Access Compliance Report

Public Rights-of-Way

(Curb Ramps)

Intersection ID: 32252	Main Street: BRYANT_FARMS_RD	Cross Street: BALMORAL_PARK_DR	Location:	E
ADA ID: 72021D286C40	Ramp Type: Perp	Initial Pass/Fail: Fail	Overall Compliance: No	Severity Score: 25

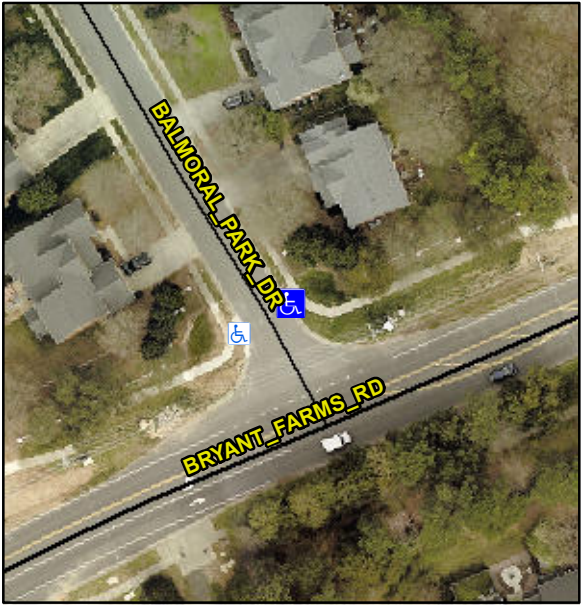
Codes/Mitigation Info/Possible Solution			Field Measurements/Component Compliance		
	Possible Solutions:		Compliance	Description	Data
	Remove & Replace Entire Ramp.		No	Ramp Length (in)	96.0
			Yes	Ramp Width (in)	48.0
			N/A	Flare Type LT	N/A
			N/A	Flare Slope LT (%)	N/A
			N/A	Flare Traversable LT?	N/A
			N/A	Landing Length (in)	N/A
			N/A	Landing Width (in)	N/A
			N/A	Landing Slope (%)	N/A
			N/A	Landing X Slope (%)	N/A
<p>Surveyor Notes:</p> <p>N/A</p> <p>PROW/ADA:</p> <p>R304.2.2, R304.5.3</p>			N/A	Flare Type RT	N/A
			N/A	Flare Slope RT (%)	N/A
			N/A	Flare Traversable RT?	N/A
			N/A	DWS Provided?	N/A
			N/A	DWS Contrast?	N/A
			N/A	DWS Length (in)	N/A
			N/A	DWS Full Width?	N/A
			N/A	DWS Offset (in)	N/A
			N/A	Shared Landing?	N/A
			N/A	Gutter Ponding?	N/A
			N/A	Gutter Lip Ht (in)	N/A
			N/A	Painted X Walk1?	No
				X Walk 1 Direction	To W
			N/A	X Walk 1 Width (in)	N/A
				X Walk 1 Slope (%)	3.4
				X Walk 1 X Slope (%)	3.2

N/A	Ramp inside XWalk1?	N/A
			N/A	Road Slope (%)	N/A
			N/A	Road X Slope (%)	N/A
			N/A	Any Obstructions?	N/A
Total Cost:		\$ 1850.00		Obstruction Type	
			N/A	Storm Grate/Utility Hazard?	N/A
				Storm Grate/Utility Type	
			N/A		N/A
			Yes	Surface Condition? (G/P)	Good
